CITY OF SANTA ANA

**RESIDENTIAL PLAN CHECK
 COMMENTS**

PLAN CHECK NO:	10173778		
PROJECT ADDRESS:	1230 W Sixth St		
PLAN CHECK ENGINEER:	George Moran	TEL: 714	667-2771
		FAX: 714	647-5897
TYPE OF CONSTRUCTION:	V B		
OCCUPANCY CLASSIFICATION(S):	R-3, U		
PLAN CHECK DATES:		REMARKS/RECHECK ITEMS:	
APPLICATION	11/30/2011	<i>810 SF addition</i>	
INITIAL REVIEW	12/8/2011		
EXPIRATION	5/28/2012		
RECHECKS:	1. <i>2-9-2012</i>	PROJECT APPLICANT CONTACT PERSON:	
	2. <i>2-8-12</i>	Jennifer Ramos	
	3. <i>2-8-12</i>	TEL:	(714)721-6928
VALUATION:	\$90,300.00	FAX:	
FLOOD ZONE:	X-0602320257J	EMAIL:

FLOOR PLANS

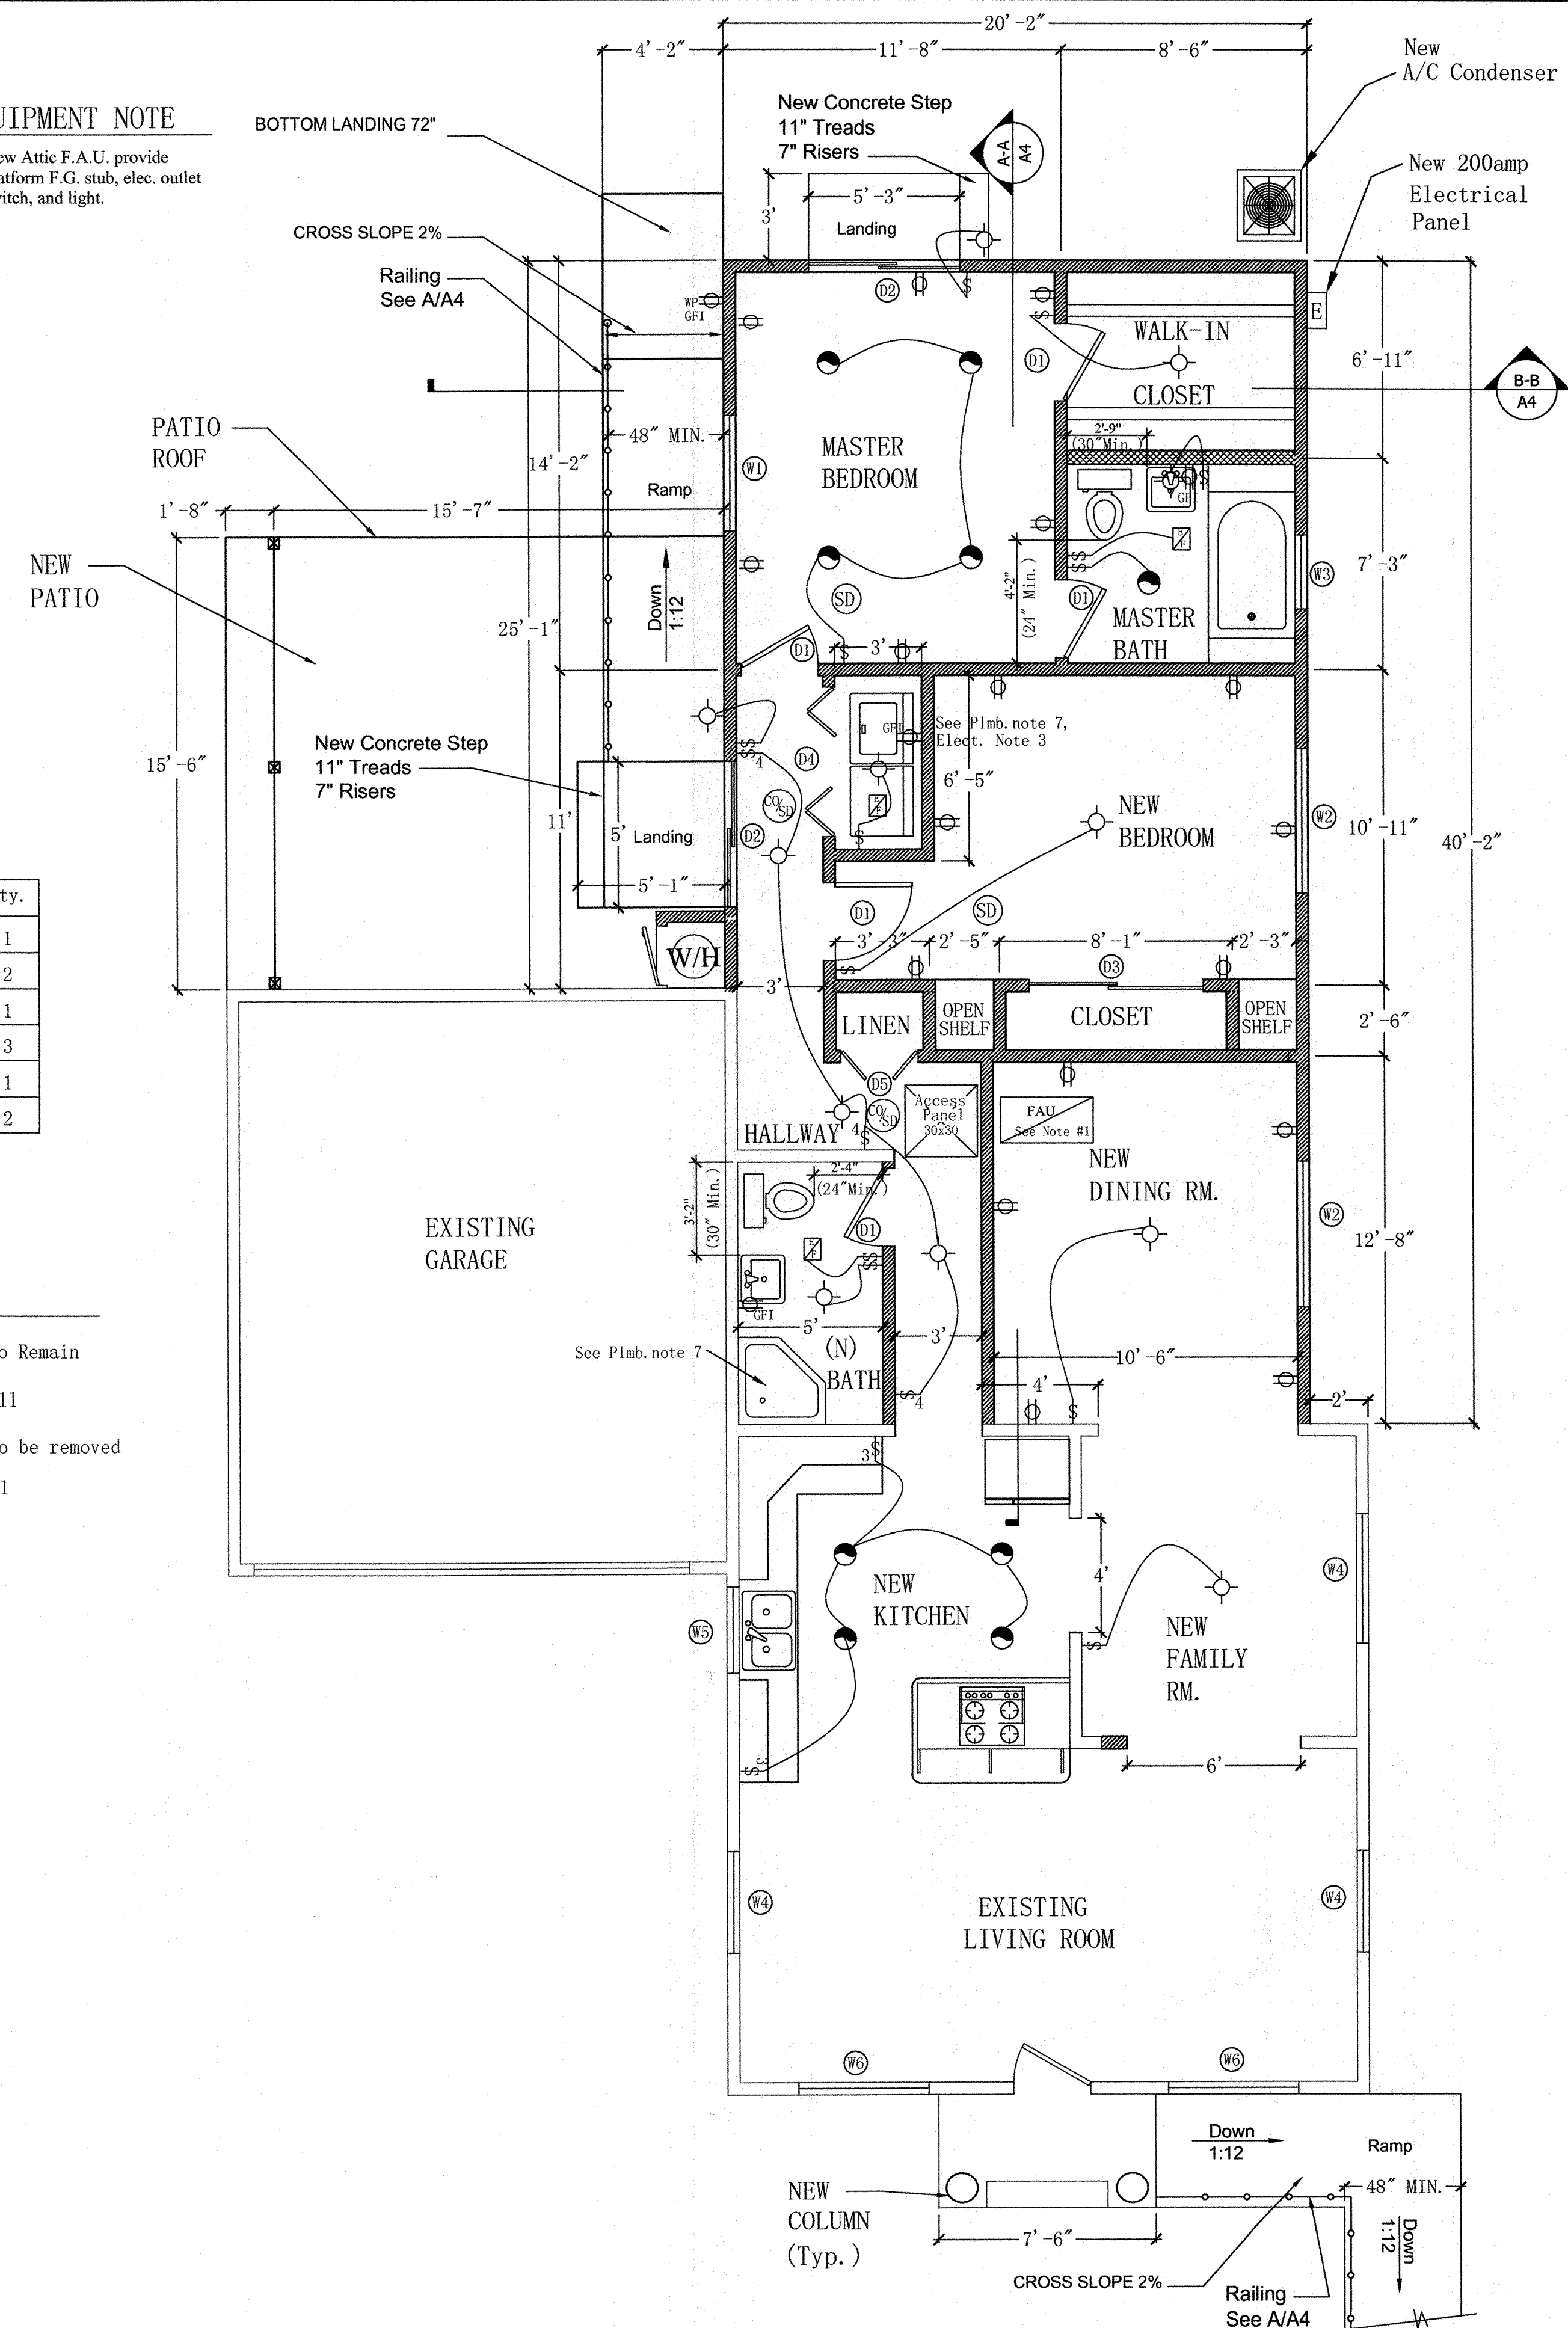
36. Revise plans to indicate how separate combustion air is provided for FAU located in attic. (CMC 701.3)

STRUCTURAL DETAILS

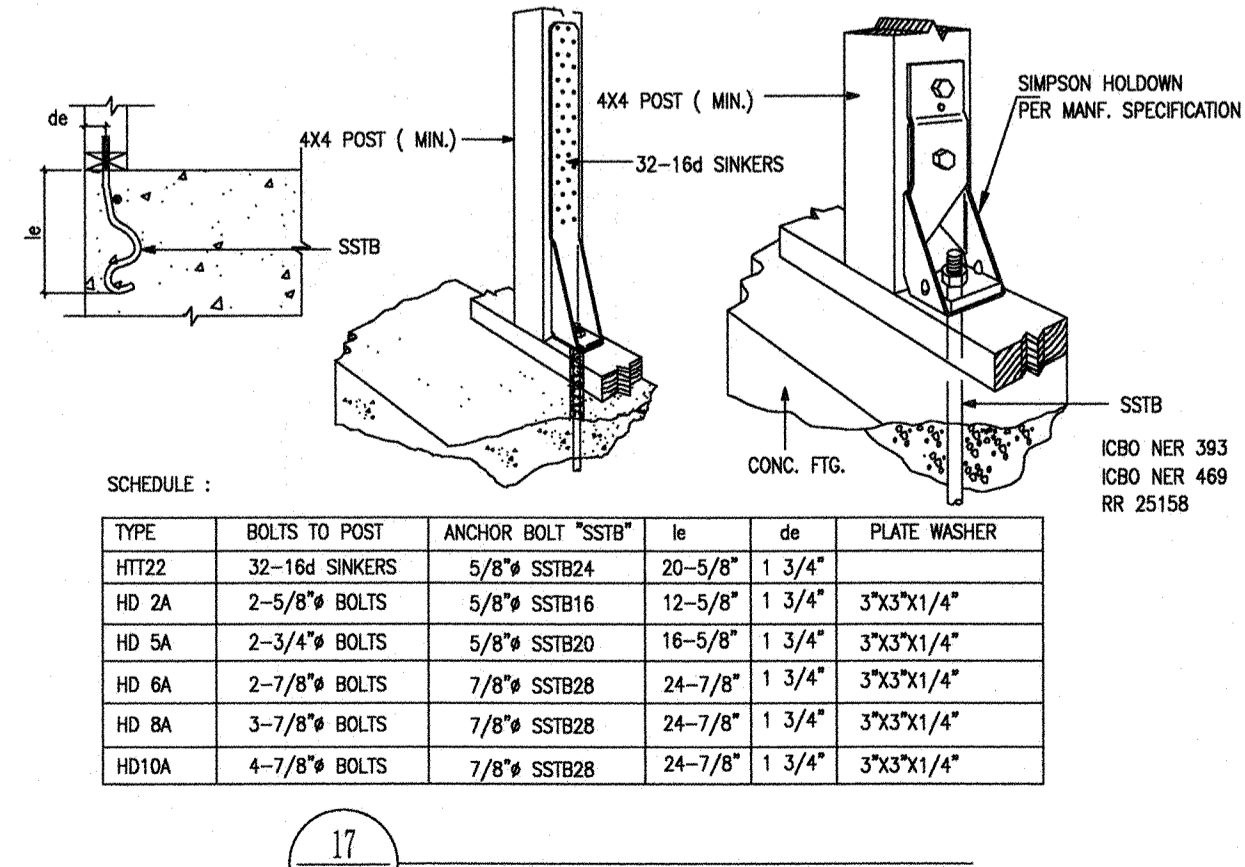
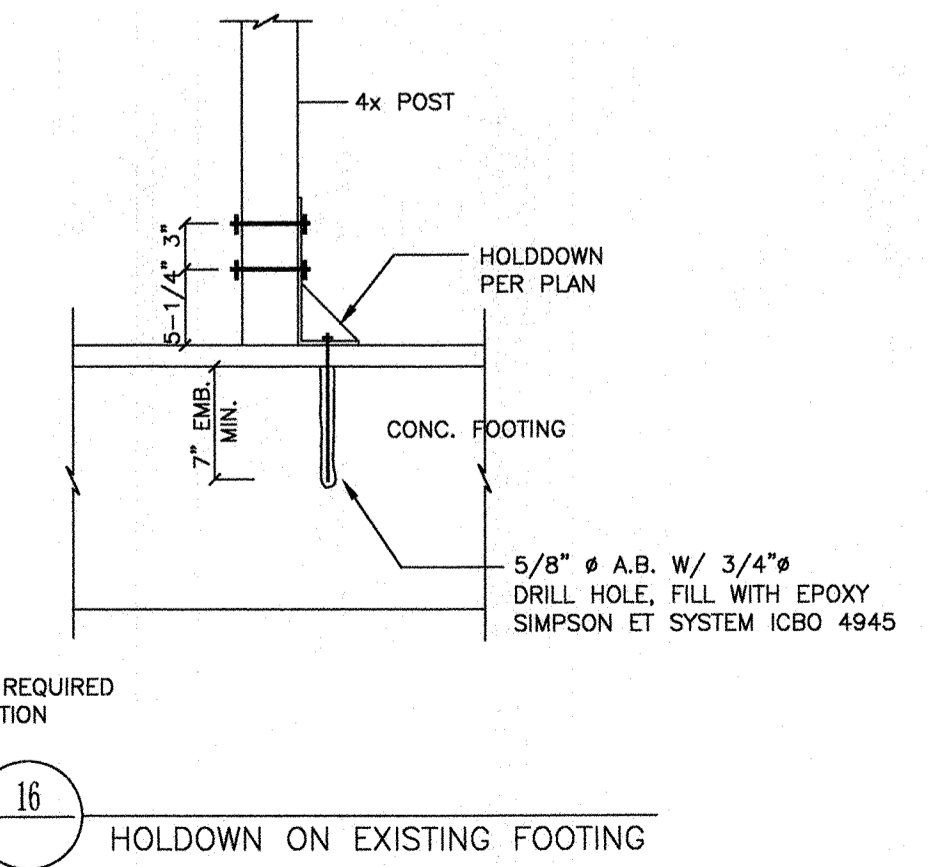
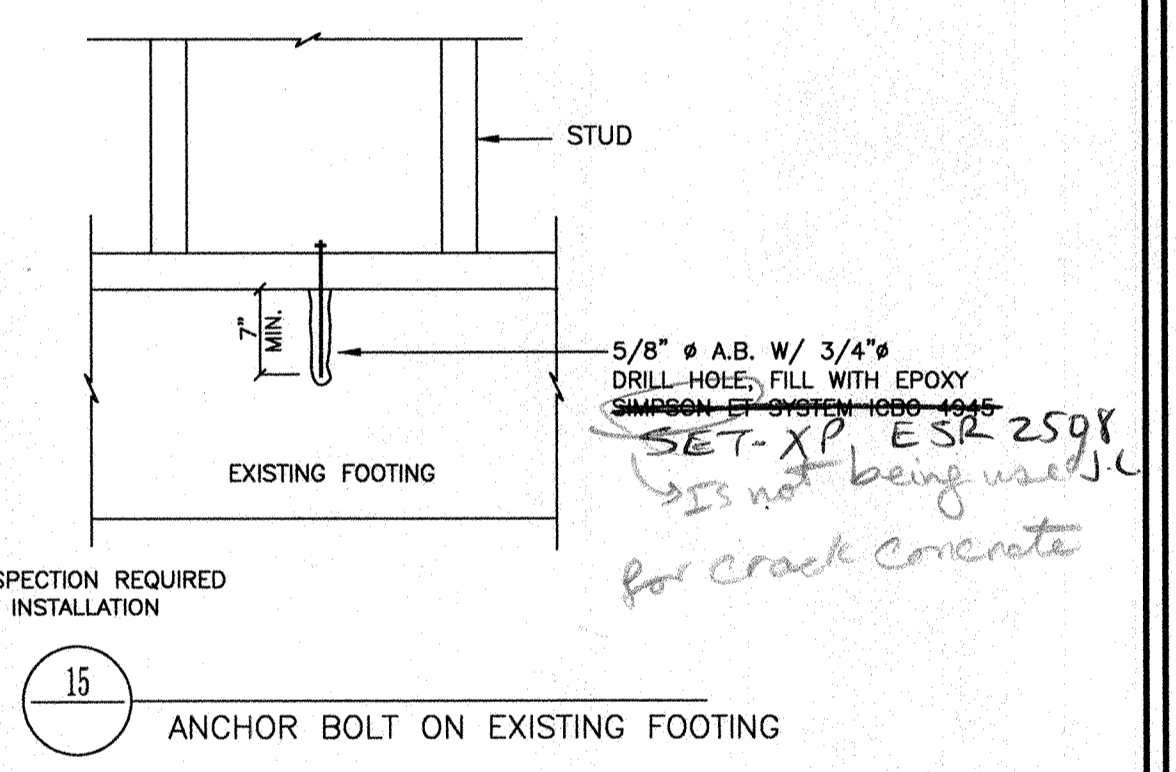
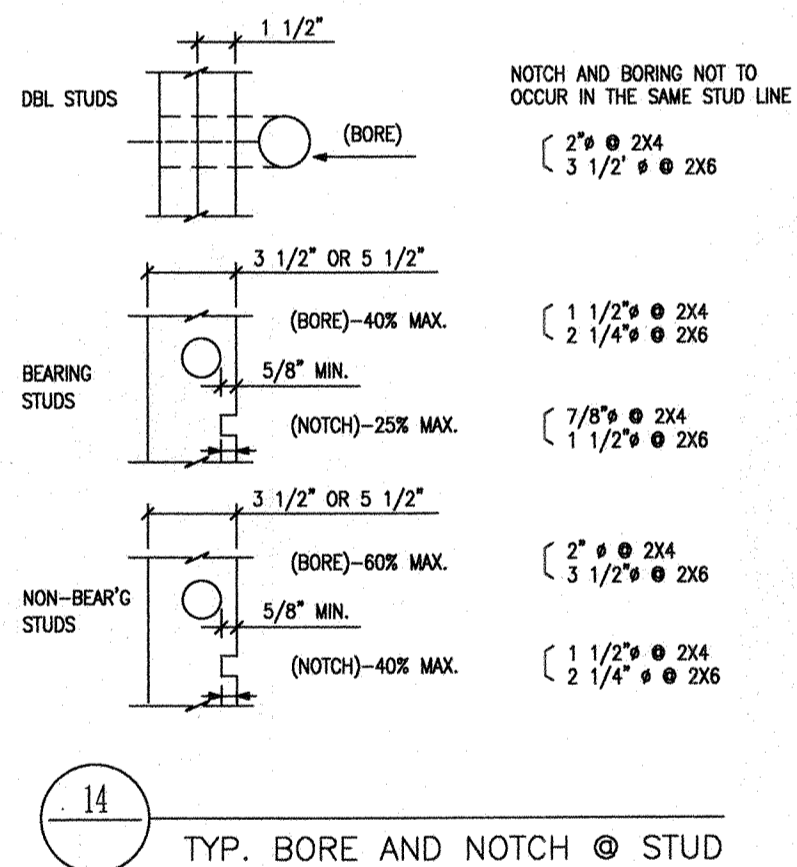
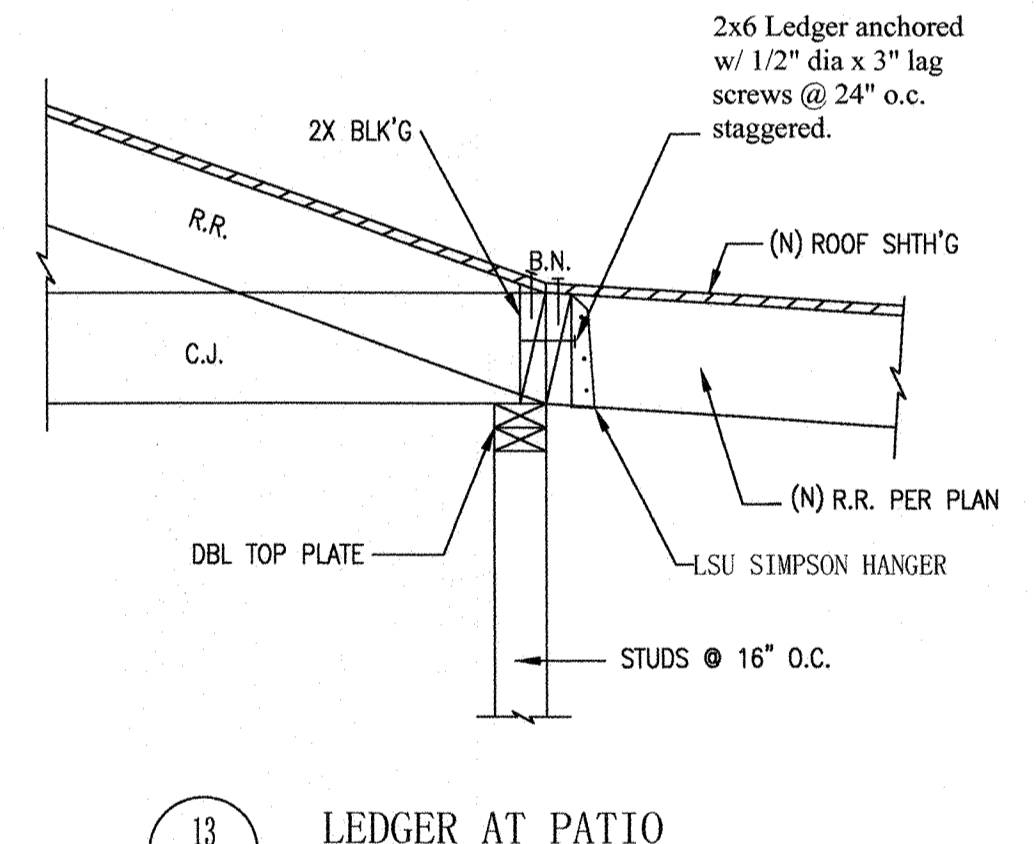
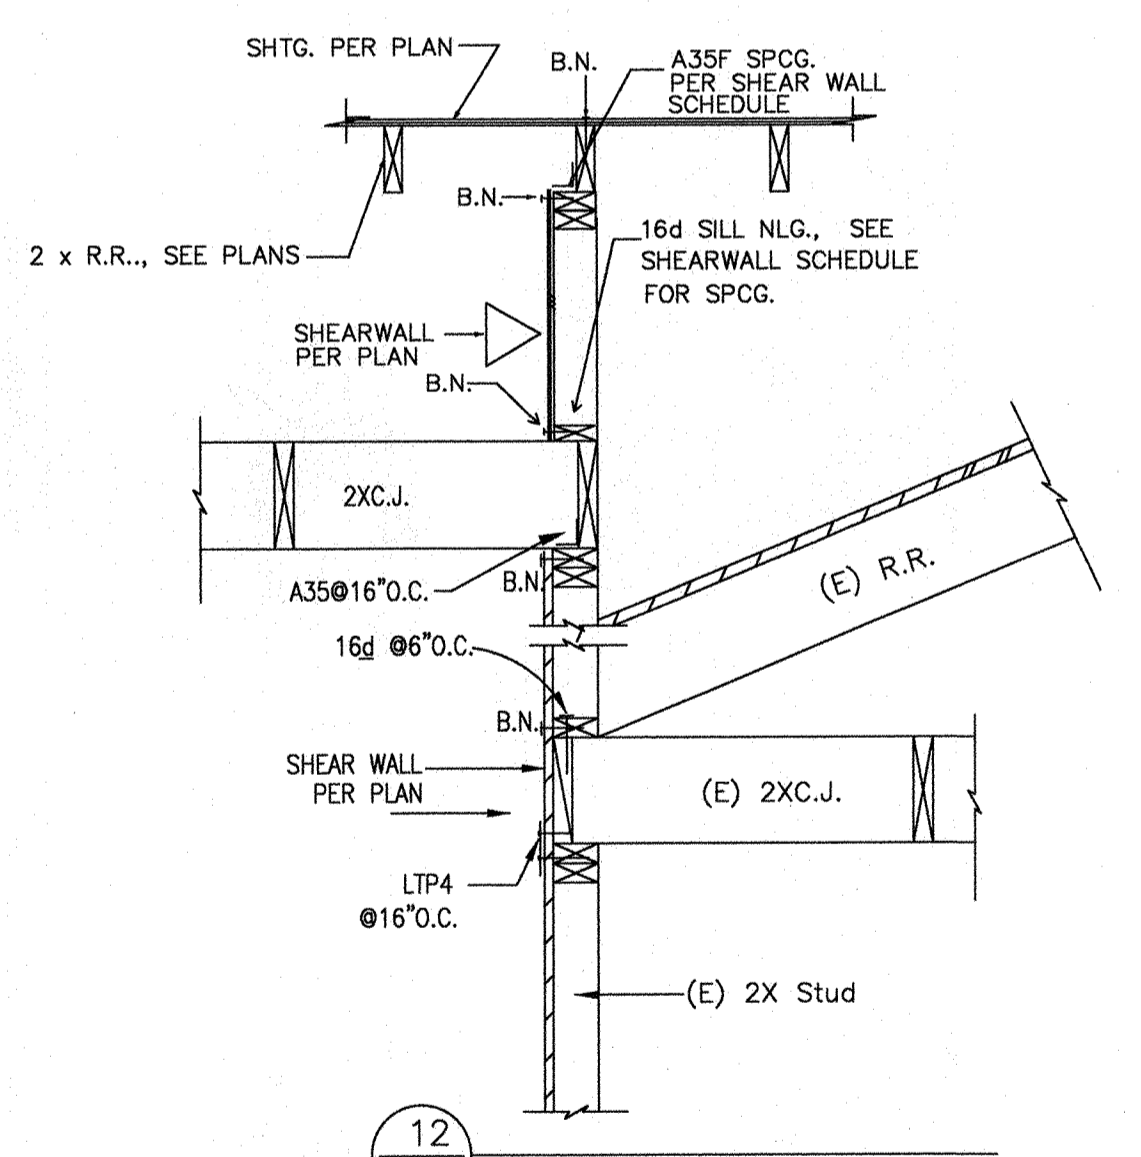
32. Provide details for retrofit shear and tension anchor bolts on plans. Provide calculations as needed? Pending Simpson ET is not approved for crack concrete.

32. Pending Simpson ET is not approved for crack concrete. Provide details for retrofit shear and tension anchor bolts on plans. Provide calculations as needed?
